PREVOST

WARRANTY BULLETIN

WB17-14B

DATE :	May 2017	SECTION :	06 ELECTRICAL
EXPIRATION:	May 2019		
SUBJECT :	INSPECTION/REPLACEMENT OF ALTERNATOR POWER CABLE STUD ADAPTER

FIGURE 2

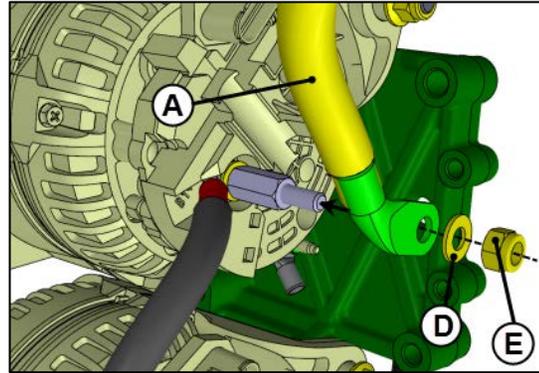
1. Remove existing hexagonal locknut **E**, flat washer **D** and power cable **A** from the stud adapter.

The existing locknut must be replaced as it is one-time use only.

The existing M8 nut « E » #5001787 is canceled and replace by nut #5001983.

2. Discard old locknut **E**.
3. Clean the anti-corrosion compound that was applied on the stud adapter **B** especially between flats.

Figure 4

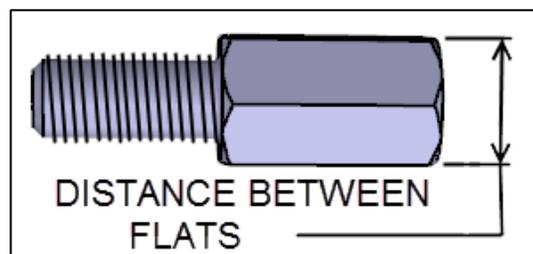
4. Inspect the distance between flats on the stud adapter. There are only two possibilities; 1/2" or 5/8".
5. First, use a 1/2" open wrench and check if you can engage the wrench between the flats of the stud. If you cannot engage the 1/2" open wrench on the stud, try a 5/8" open wrench and check if you can engage this second wrench between the flats of the stud and if it fits tight.

6. If the distance between flats is $5/8$ " , you have the correct stud. Move to step 7.

If the distance between flats is $1/2$ " , you have the wrong stud and you need to change it. Move to step 10.

Figure 7

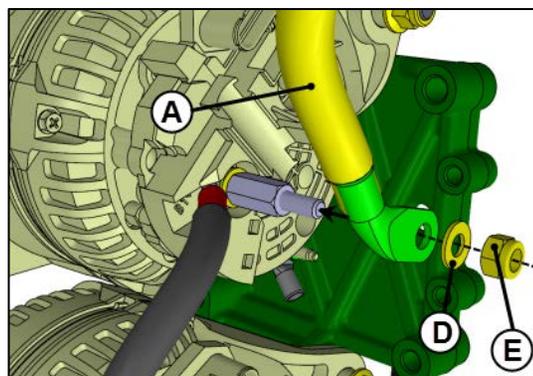
7. Reinstall power cable **A**. To do so, connect power cable **A** to the stud adapter, install the flat washer **D** and the new locknut **E**.
8. **Protect the alternator stud and cable terminal against corrosion.** Apply anti-corrosion compound or **Color Guard Rubber Coating** on the stud adapter, the cable terminal, and the locknut.
9. Bulletin is complete.

E: LOCKNUT M8 #5001983 (*torque: 10 lbf-ft*)

FIGURE 8

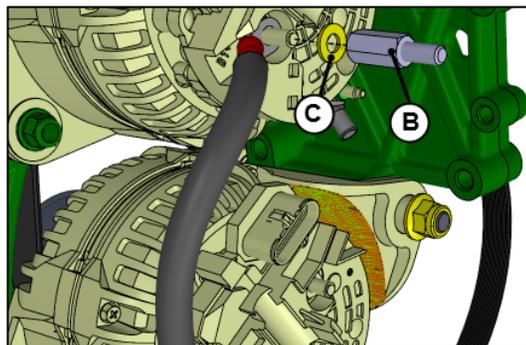
10. Remove old stud adapter **B** (FIGURE 8).
11. Before installing the power cable, make sure that the nut that secures the alternator stud is properly tightened (FIGURE 9).
12. Install appropriate new stud adapter **B**. Make sure the jumper cable terminal and the flat washer **C** are still in place (FIGURE 8).

B : STUD ADAPTER #060297 (*torque: 10 lbf-ft*)

FIGURE 10

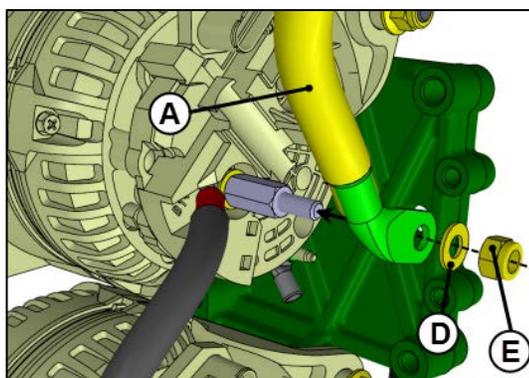
13. Reinstall power cable **A**. To do so, connect power cable **A** to the stud adapter, install the flat washer **D** and the new locknut **E**.
14. **Protect the alternator stud against corrosion.** Apply anti-corrosion compound or **Color Guard Rubber Coating** on the stud adapter, the cable terminal and the locknut.
15. Bulletin is complete.

E: LOCKNUT M8 #5001983 (*torque: 10 lbf-ft*)
